Product Change Notification / CAAN-27VKXJ630

CCB 6849 Initial Notice: Qualification of STA as an additional assembly site for selected AT42QT1x, AT42QT21, AT42QT41, ATmega16, ATmega32, ATmega48, ATmega8x, ATtiny26, ATtiny46, ATtiny8x, QT60160 and QT60240 device families available in 32L VQFN (5x5x1mm) package.

CCB 6849
Pre and Post Change Summary
PCN #: CAAN-27VKXJ630

ANAC

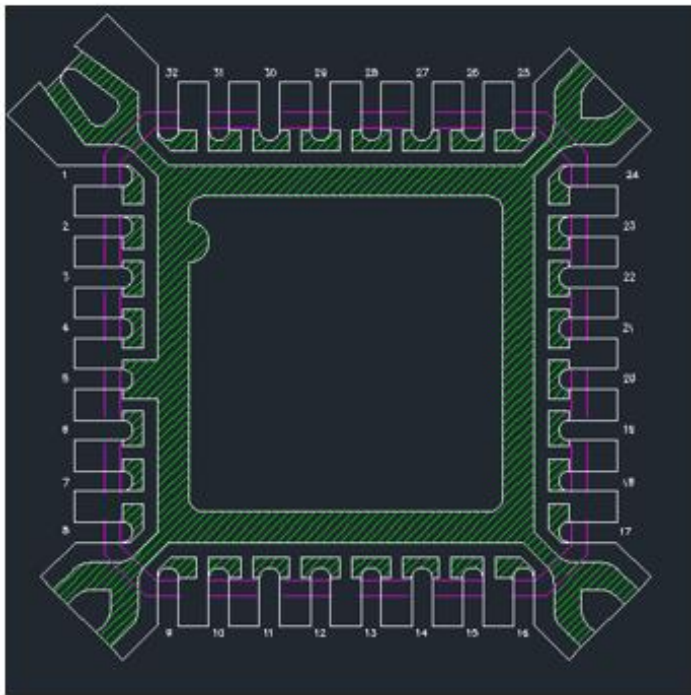
Wire Material	Au	CuPd
Lead-Frame Paddle Size	146X146mils	
Lead-Frame Material	C194	
Lead-Frame Lead Lock	No

STA

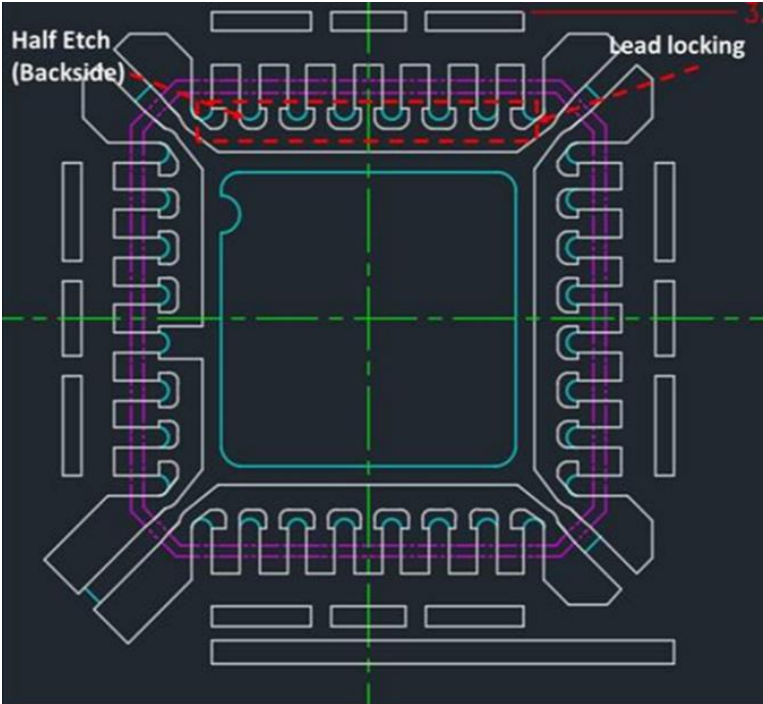
Wire Material	Au	CuPdAu
Lead-Frame Paddle Size	138X138mils	
Lead-Frame Material	C194	
Lead-Frame Lead Lock	Yes
